From: Dave Hart <davehart@dcn.davis.ca.us>
To: Phillips 66 Oil By Rail Project
<P66-railspur-comments@co.slo.ca.us>
Date: 11/23/2014 10:26 PM
Subject: Phillips 66 Rail Spur Extension Project

Responses to Dave Hart Comments

Figure 1. Railroad Accident Rate 2004 – 2014

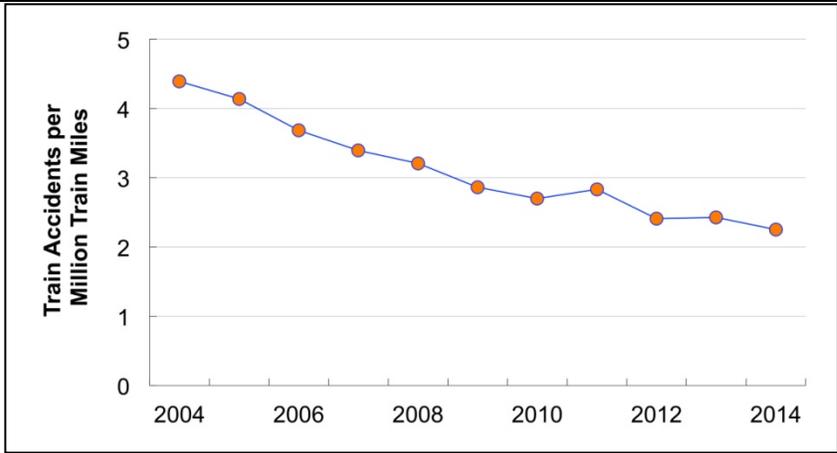
First, I am most immediately concerned with the very poor record of rail safety as outlined by the California Public Utilities Commission as reported for the latest year on their public website <http://www.cpuc.ca.gov/PUC/safety/Rail/Railroad/railroadsafety.htm>. The record indicates that the rail industry is dangerous to begin with without the addition of dangerous oil payloads as measured by derailments large and small and as measured by injuries to rail workers and the public. Adding the element of 80 to 100-car trains carrying volatile and flammable materials seems like folly.

The railroad accident rate has been steadily trending downward for over a decade. The accident rates in the past few years were the lowest since the FRA started recording the data in the mid-1970s. In the period from 2004 to 2014 the rate declined by 49% (almost half) (see Figure 1 below). Most derailments receive little or no attention from the public or media. Railroads are required by regulation to report all accidents that exceed a certain monetary threshold in damage to track, signals and rolling stock (currently \$9,600). Proper estimation of train accident rates involves analysis of all accidents, divided by the total amount of traffic. The reason that some perceive an increase in the railroad petroleum crude oil accident rate is because of the more than 50-fold increase in this traffic since 2009. Estimates are that 233,698 tank cars of crude oil were moved by rail in 2012. This increased to over 435,000 tank cars moved by rail in 2013 (the full year of data is not yet available for 2014). With this increase in crude by rail traffic, the derailment and spill probability data would suggest that multiple crude by rail accidents would happen each year.
